ADDENDUM NO. 03

Date: 09.19.2025

Project: Sheridan HS and MS School Renovation Project

The Hagerman, Inc portion of this Addendum consists of the following information:

UNDERSLAB
PLAN - UNIT B PLUMBING
DEMOLITION

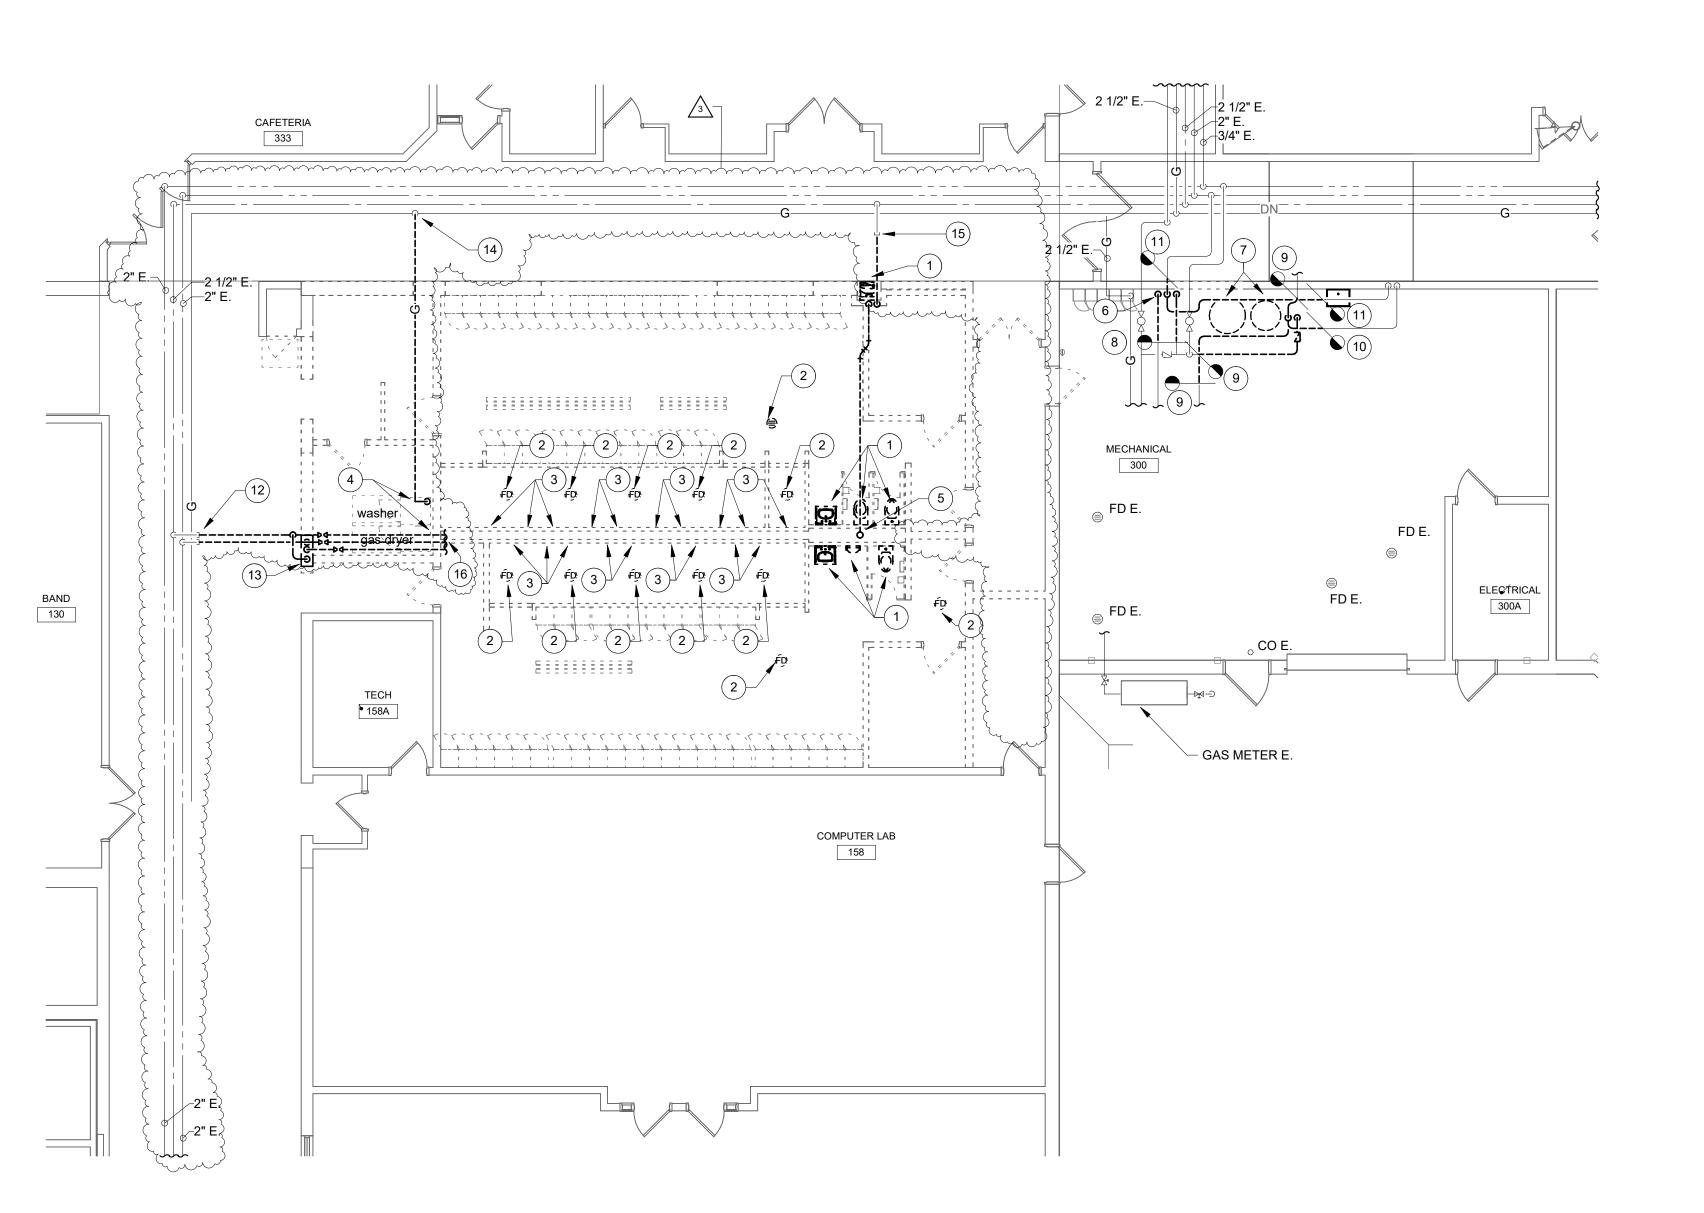
- 3.16 PD101B UNDERSLAB PLAN UNIT B PLUMBING DEMOLITION
 - A. Add underslab piping to be demolished.
 - B. Replace sheet in its entirety.
- 3.17 PD201A GROUND FLOOR PLAN PLAN UNIT A PLUMBING DEMOLITION

PD201B PROJECT NUMBER

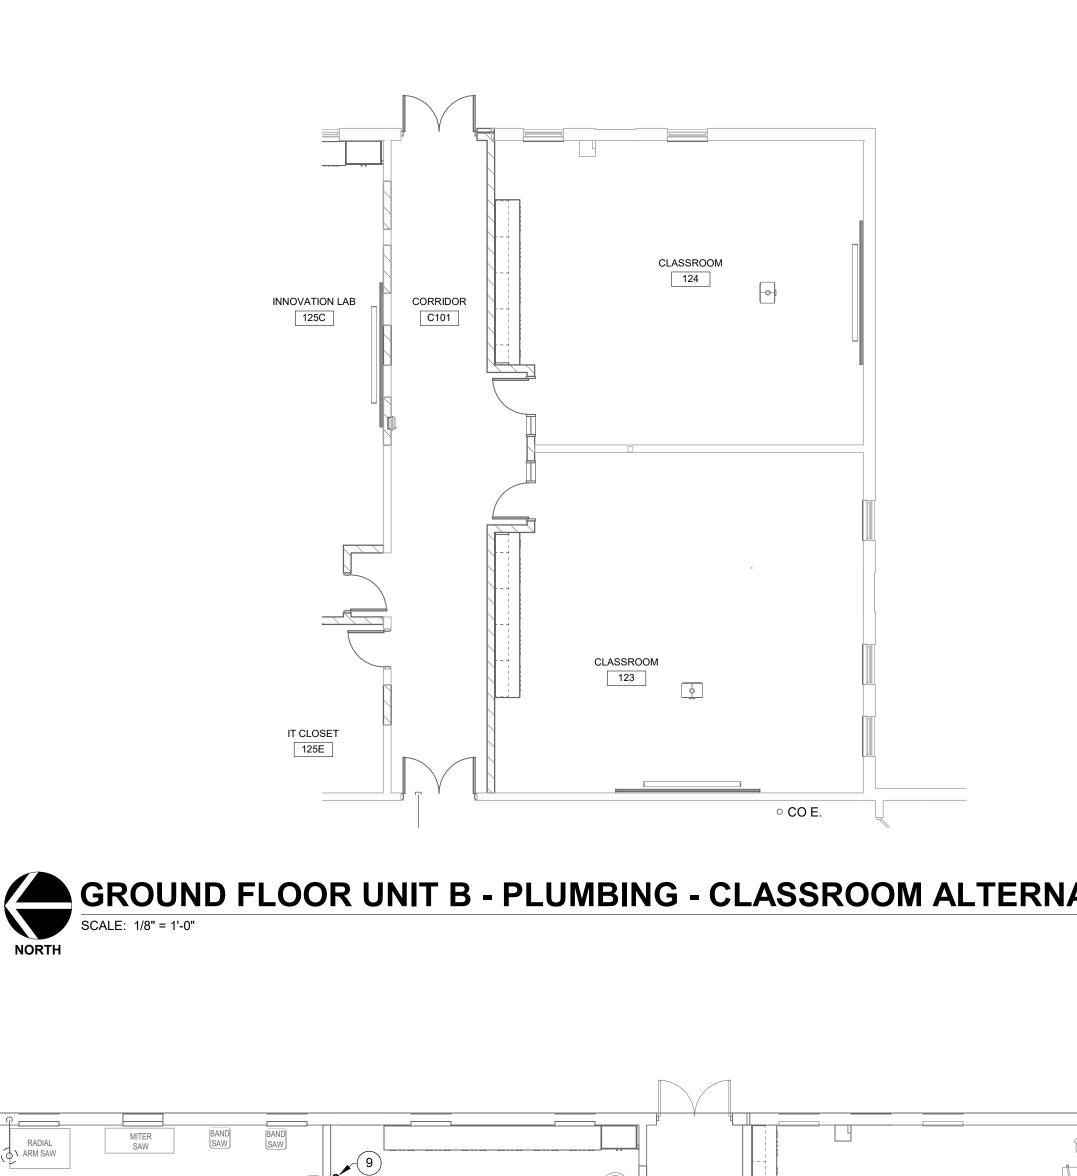
- 23.Bid Item #13 Mechanical Contractor shall be responsible for Plan Notes 9, 10, 11, and 12 on Drawing PD201B in addition to the revised Plan Note 1. Note: Bid Item #01 General Trades Contractor to be responsible to furnish and install only the concrete infill work per the Original Scope of Bid.

3.18 PD201B – GROUND FLOOR PLAN – UNIT B – PLUMBING DEMOLITION

- A. Revise location of domestic water piping to be demolished.
- B. Add demolition of sink and piping.
- C. Add gas piping to be demolished.
- D. Revise plan note 1.
- E. Add plan note 9, 10, 11, and 12.
- F. Replace sheet in its entirety.

PLAN - UNIT B -**PLUMBING**

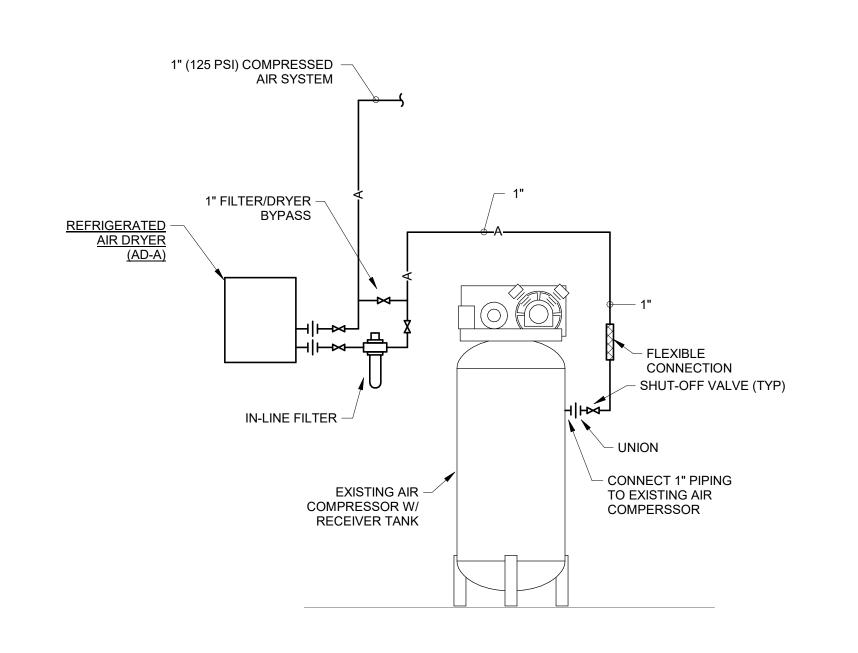
- 24.Bid Item #13 Mechanical Contractor shall be responsible for General Note 2 on Drawing P201B in addition to revised Plan Notes 10, 11, and 12. Refer to drawing A210B to determine which areas overhead piping is to be exposed.

- 25.Bid Item #13 Mechanical Contractor shall furnish and install the circuit setter "CS-1" per Drawing P201B and specs.
- 26.Bid Item #12 Fire Protection Contractor shall be responsible for Plan Note 8 on Drawing FP201D in addition to revised Plan Note 6.

3.19 P201B – GROUND FLOOR PLAN – UNIT B – PLUMBING

- A. Revise location of domestic water piping connection point in corridor.
- B. Add hot water, cold water and hot water return piping for fixtures in agricultural lab 128.
- C. Add circuit setter (CS-1).
- D. Delete electric water heater.
- E. Revise plan note 10, 11, and 12.
- F. Add general note 2.
- G. Replace sheet in its entirety.

MD201A

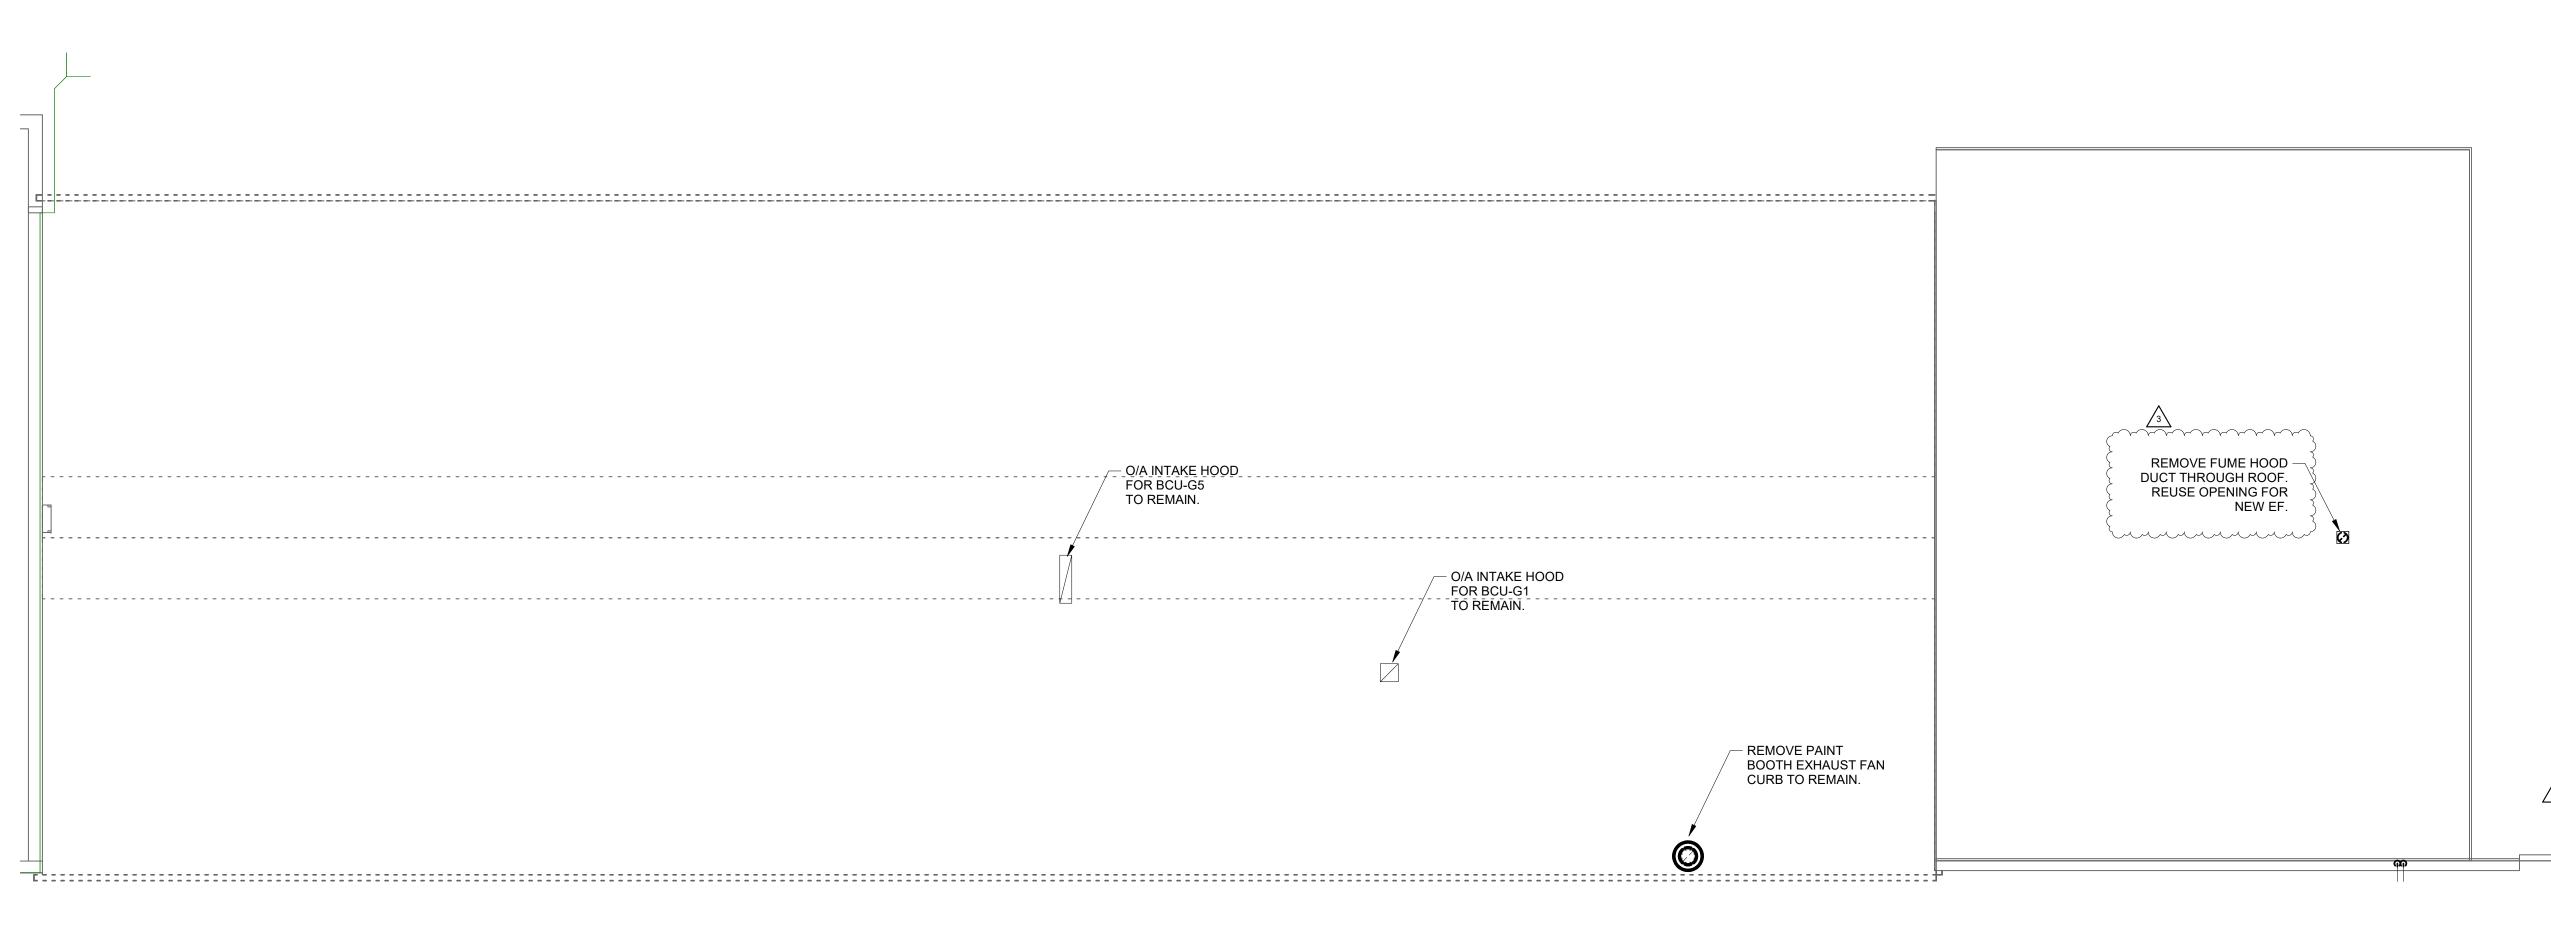
- 27.Bid Item #12 Fire Protection Contractor shall be responsible for Plan Note 4 on Drawing FP201D in addition to revised Plan Note 2.
- 28.Bid Item #13 Mechanical Contractor shall be responsible for Plan Notes 7, 8, 9, and 10 on Drawing MD201A.

3.24 <u>MD201A – GROUND FLOOR PLAN – UNIT A – MECHANICAL DEMOLITION</u>

- A. Exhaust Ductwork shown.
- B. Heating water supply and return piping to locker room CUHs and AHU to be removed now shown.
- C. Plan Note #7: REMOVE HEATING WATER SUPPLY AND RETURN PIPING BACK TO VALVES AND CAP.
 - 1. This note applies to the piping serving the (2) ceiling mounted CUH, the (1) wall mounted CUH, and the abandoned AHU heating coil and its reheat coil piping.
 - 2. The valves are located in the 158A Tech room.
- D. Plan Note #8: REMOVE ABANDONED PNEUMATIC CONTROLS COMPLETELY.
 - 1. This applies to the pneumatic controls that served the abandoned AHU and AHU-6.
- E. Plan Note #9: TEMPERATURE CONTROL PANEL TO BE RELOCATED.

- 1. This applies to the TCP located high on the block wall that is removed. Relocate panel to new Dry Storage.
- F. Plan Note #10: DUCTWORK TO REMAIN.
 - 1. This applies to the ductwork that runs East/West within the Girls Locker Room. Bottom of duct approximately 14' above floor.

DRAWING TITLE: GROUND FLOOR PLAN - UNIT B -MECHANICAL **DEMOLITION**

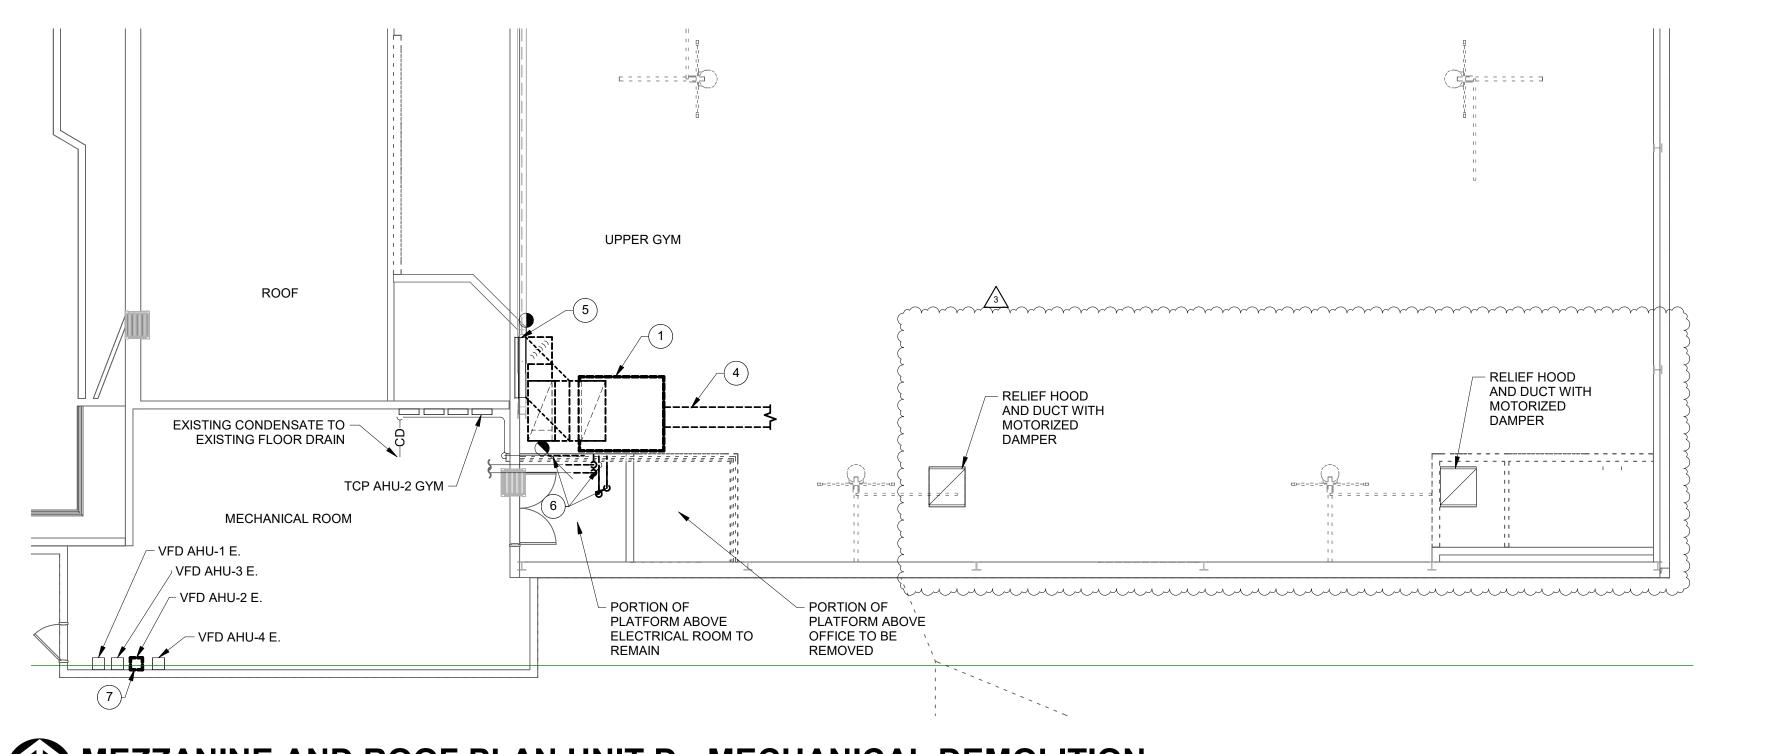
- 29.Bid Item #13 Mechanical Contractor shall be responsible for Plan Notes 13, 14, 15, 16, 17, 18, and 19 on Drawing MD201B.
- 30.Bid Item #02 Masonry Contractor shall be responsible for patching the existing CMU opening for the existing A/C unit to be removed per Plan Note 13 on MD201B. Refer to section 00 25 00 for photo of this wall.

3.25 MD201B – GROUND FLOOR PLAN – UNIT B – MECHANICAL DEMOLITION

- A. Plan Note #13: REMOVE WINDOW AIR CONDITIONER COMPLETELY.
 - 1. Window AC in Storage 128D.
- B. Plan Note #14: CABINET UNIT HEATER TO REMAIN.
 - 1. Cabinet Unit Heater in Storage 128D.
- C. Plan Note #15: REMOVE FINNED TUBE RADIATION BEHIND CASEWORK
 - 1. Applies to Rooms 123, 124, and 128 AG.
- D. Plan Note #16: TEMPERATURE CONTROL PANEL TO BE RELOCATED WITHIN NEW IT ROOM.
 - 1. Applies to TCP in IDF 123B.
- E. Plan Note #18: PIPING THROUGH FLOOR TO VUV TO REMAIN.
 - 1. Applies to VUV-124.
- F. Plan Note #19: REMOVE PIPE INSULATION IN SHOP AREA.
 - 1. Applies to HS, HR, CHWS, CHWR
- G. Removed Fume Hood discharge through roof does not have a curb suitable for new Exhaust Fan EF-123C.
